Access Compliance Report

Public Rights-of-Way

(Curb Ramps)

Intersection ID: N/A	Main Street: ROCKY_RIVER_RD	Cross Street: JOHN_RUSSELL_RD	Location: SW
ADA ID: AD77B714C4F3	Ramp Type: Perp	Initial Pass/Fail: Fail	Overall Compliance: No
Severity Score: 21.25			
Codes/Mitigation Info/Possible Solution		Field Measurements/Component Compliance

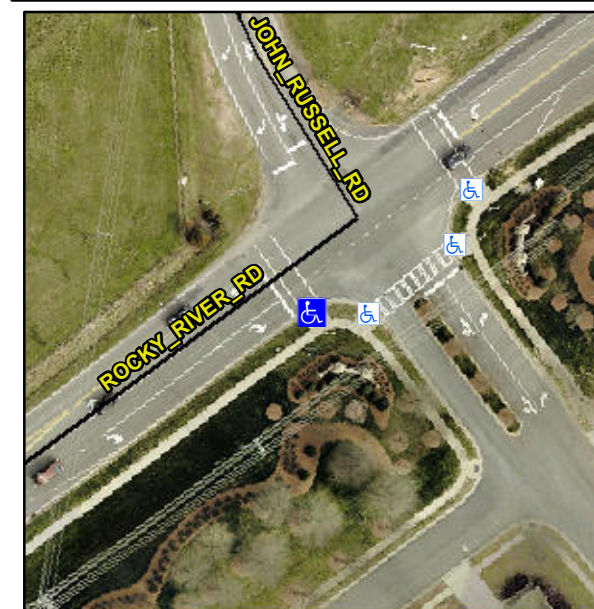
Not Found, R304.5.1, R304.2.2

Compliance	Description	Data	Compliance	Description	Data
N/A	Ramp Length (in)	96.0	No	Ramp Slope (%)	11.0
No	Ramp Width (in)	47.0	Yes	Ramp XSlope (%)	0.5
N/A	Flare Type LT	N/A	N/A	Flare Type RT	N/A
N/A	Flare Slope LT (%)	N/A	N/A	Flare Slope RT (%)	N/A
N/A	Flare Traversable LT?	N/A	N/A	Flare Traversable RT?	N/A
N/A	Landing Length (in)	N/A	N/A	DWS Provided?	N/A
N/A	Landing Width (in)	N/A	N/A	DWS Contrast?	N/A
N/A	Landing Slope (%)	N/A	N/A	DWS Length (in)	N/A
N/A	Landing X Slope (%)	N/A	N/A	DWS Full Width?	N/A
N/A	Landing Curb? (Y/N)	N/A	N/A	DWS Offset (in)	N/A
N/A	Shared Landing?	N/A			
N/A	Gutter Ponding?	N/A	N/A	Gutter Slope (%)	N/A
N/A	Gutter Lip Ht (in)	N/A	N/A	Gutter X Slope (%)	N/A
N/A	Painted X Walk1?	Yes	N/A	Painted X Walk2?	N/A
	X Walk 1 Direction	To NW		X Walk 2 Direction	N/A
N/A	X Walk 1 Width (in)	112.0	N/A	X Walk 2 Width (in)	N/A
	X Walk 1 Slope (%)	2.0		X Walk 2 Slope (%)	N/A
	X Walk 1 X Slope (%)	0.3		X Walk 2 X Slope (%)	N/A

Remove & Replace Entire Ramp.
